Project	IEEE 802.16 Broadband Wireless Access Working Group < <a href="http://ieee802.org/16">http://ieee802.org/16</a> >
Title	Closed-loop MIMO Enhancement
Date Submitted	2004-11-13
Source(s)	Bin-Chul Ihm, Yongseok Jin, Jinyoung Chun, Kyuhyuk Chung LG Electronics, Inc. 533, Hogye-1dong, Dongan-gu, Anyang-shi, Kyongki-do, Korea Voice: 82-31-450-7187 Fax: 82-31-450-7912 [mailto: {bcihm, jayjay, jychun03, kyuhyuk }@lge.com]
Re:	This is a response to a Call for Comments on IEEE P802.16e-D5
Abstract	We propose a closed-loop MIMO method and feedback scheme
Purpose	This document is submitted for review by 802.16e Working Group members. <u>underline green indicates new revised text change to the Standard</u>
Notice	This document has been prepared to assist IEEE 802.16. It is offered as a basis for discussion and is not binding on the contributing individual(s) or organization(s). The material in this document is subject to change in form and content after further study. The contributor(s) reserve(s) the right to add, amend or withdraw material contained herein.

# Closed-loop MIMO enhancement

Figure 1. Two cases for channel estimation using pilots or midamble

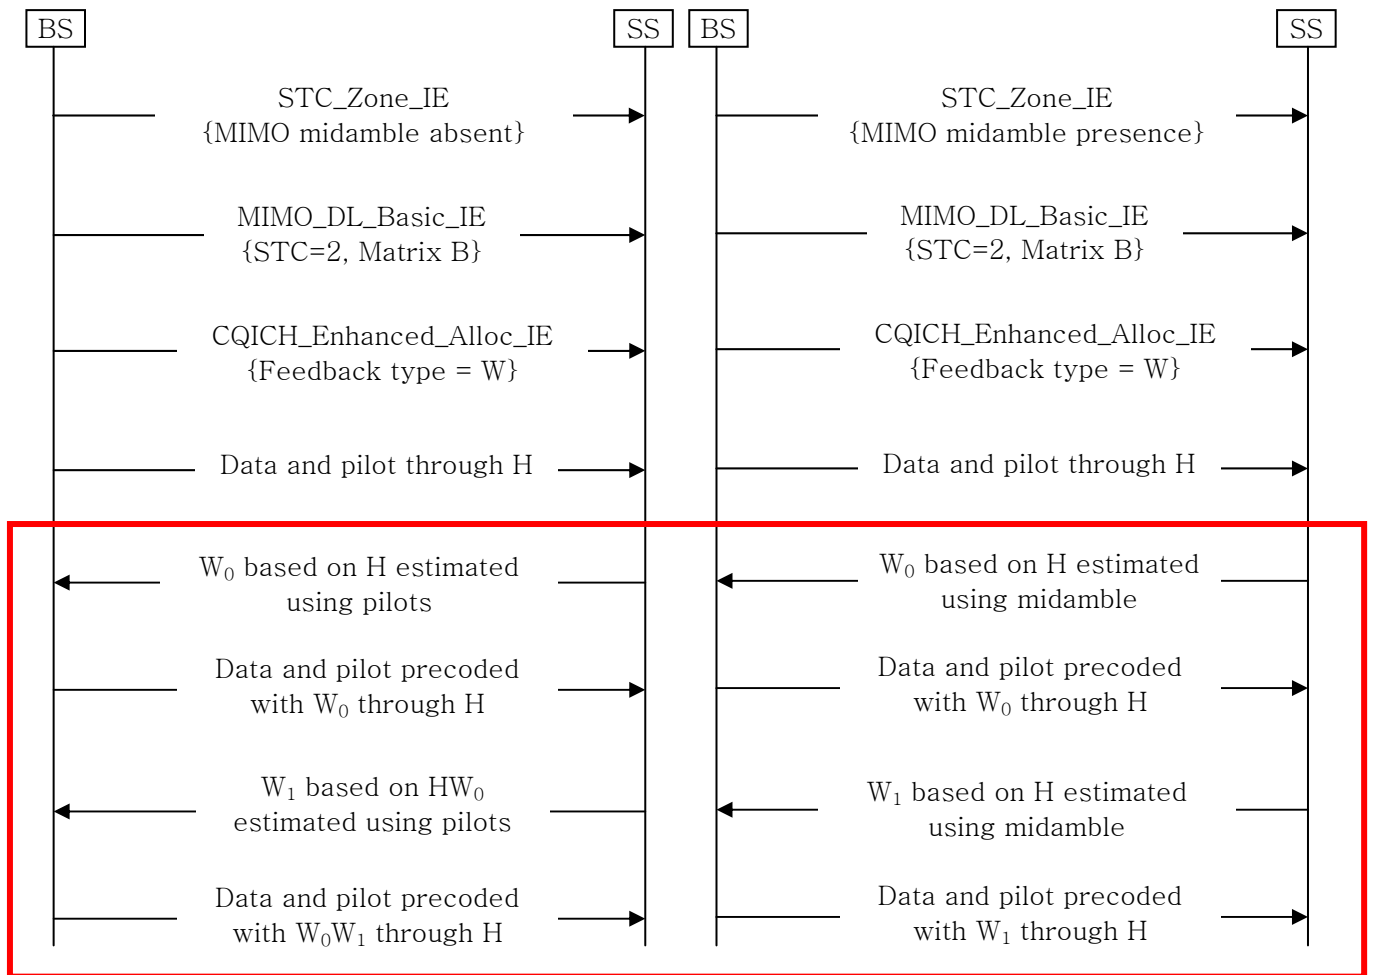
As shown in Figure 1, BS sends the data precoded with  $W$  sent back by MSS where  $W$  is different according to which known signals (pilots or midamble) are used for channel estimation. Furthermore, when using pilots in the burst for channel estimation, BS has to save the previous  $W$  ( $W_0$ ) because MSS computed the new  $W$  ( $W_1$ ) based on  $H W_0$ . Therefore, there shall be a rule for use of pilots or midamble for channel estimation or BS should indicate MSS to use pilots or midamble for channel estimation.

[W is derived from pilots and/or midamble when Nt = Mt and BS indicates MS to use one of them in case of their coexistence. When Nt > Mt, W is obtained from only midamble.](#)
